To: Rich Kosko The Hanson Group

The Hanson Group, Ltd.

Receiver Insert

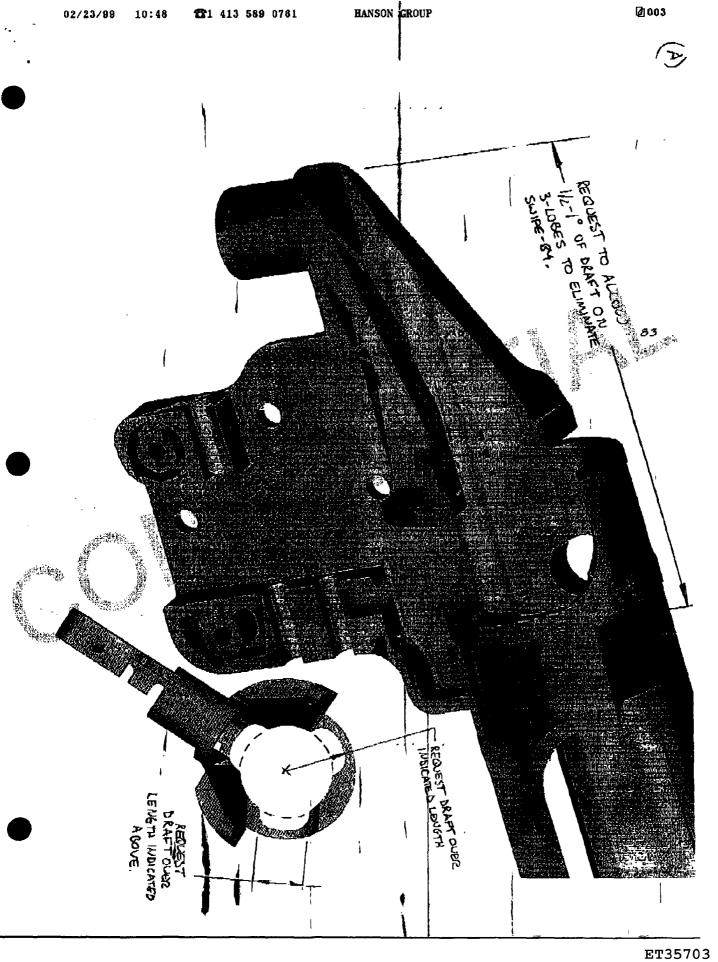
the Engineering Department would like to request the following changes to the Receiver Insert which would allow us to produce a more stable and accurate part. The requests are as follows: (1) We would like to add 1/2 to 1 degree of draft on the last few inches of the insert as shown on the diagram labeled (A). If you can give it to us on the full length of the piece it would be even better. (2) We would like to add the same amount of draft to the lobes. This would eliminate the swipe by action. On diagram labeled (B) we would like to request a 5 to 10 degree chamfer extended for the entire length of the slot on all three (3) sides. This will also climinate the swipe by condition and help the cores to interlock. Attached are two solid model diagrams for your review with reference to the areas of our concern. Thank you in advance for your consideration to allow these

In reference to your fax submitted on 2/23/99, Issues (1) and (2) pertain to draft of the three internal lug clearance areas; 1/2 to 1 degree of draft will be permissible on each individual lug clearance from the 1.046 diameter external ring rearward (direction of pull), no draft beyond tolerance will be permissible on the core diameter of .701 +/-.002.

Per our phone conversation issues with regards to sketch (B) are not required and will not be addressed.
